The Brooks Requests a Continuous Noise Abatement Wall Along the East Side of The Brooks

We represent the five communities in the Brooks consisting of 3,654 home, 4236 registered voters, and about 7,000 residents. The Brooks is adjacent to I-75 as shown in the Figure 1. We are requesting the construction of a continuous 22' noise abatement wall along the entire east side of The Brooks in Estero (mile marker 120-122).

Figure 1
The Brooks Communities Request A Continuous Wall Along I-75
 FDOT July 2025 Draft Noise Study Proposal and The Brooks Proposal

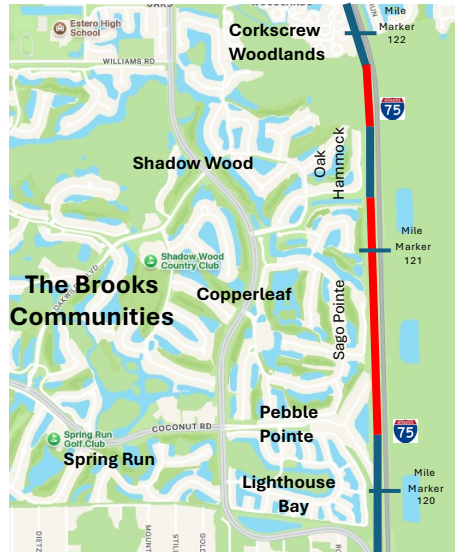
- Calls for wall segments along the Brooks but also says that a “relatively long, continuous wall” is more effective. The wall segments are shown in Figure 1 in dark blue; the requested wall is shown in red.

- FDOT Draft Proposed 22' high wall.
- Brooks Proposed 22' addition making a continuous wall along The Brooks

To summarize, the residents of the Brooks Communities are asking for the construction of a long continuous 22' noise abatement wall along the expanded I-75 by The Brooks in Estero (mile marker 120-122).

Figure 2
Why The Different Treatment Of Oak Hammock and Sago Pointe?

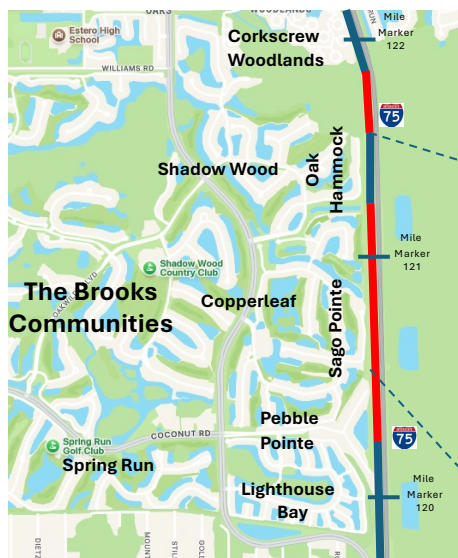
- Recommends a wall along Oak Hammock but not Sago Pointe (see Figure 2). Both condo complexes are the same size and both are 140 feet from the I-75 right-of-way. Identical units but different treatment by FDOT.

- Oak Hammock and Sago Pointe are almost identical condos, same size and both 140' from I-75 ROW.
- FDOT recommends a wall for Oak Hammock but not Sago Pointe in the FDOT Draft Noise Study.

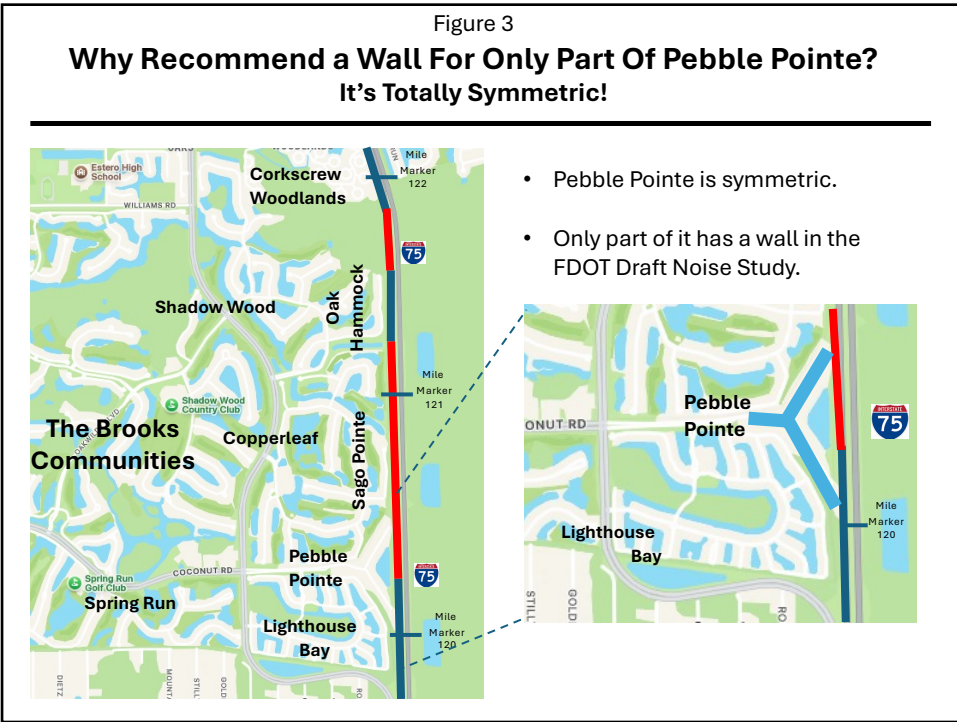
- Recommends a wall along part of Pebble Pointe. But Pebble Pointe is a totally symmetric “martini glass” as shown in Figure 3. Again, inconsistent treatment by FDOT.

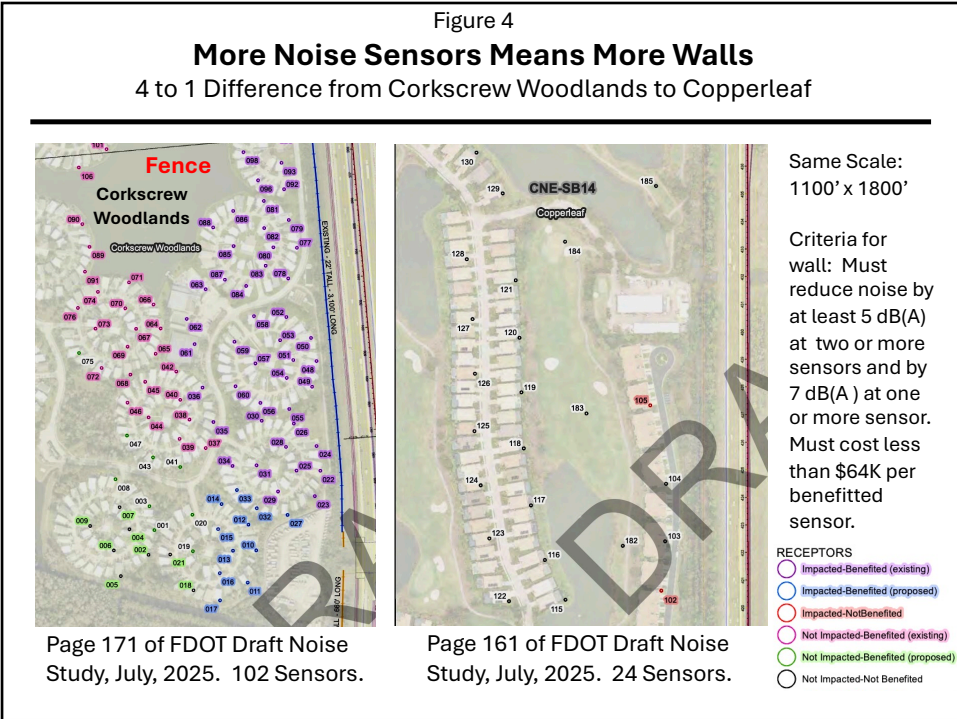
- A reason for the inconsistent treatment may be the much lower density of noise sensors in The Brooks when compared with Corkscrew Woodlands just north of The Brooks as shown in Figure 4.
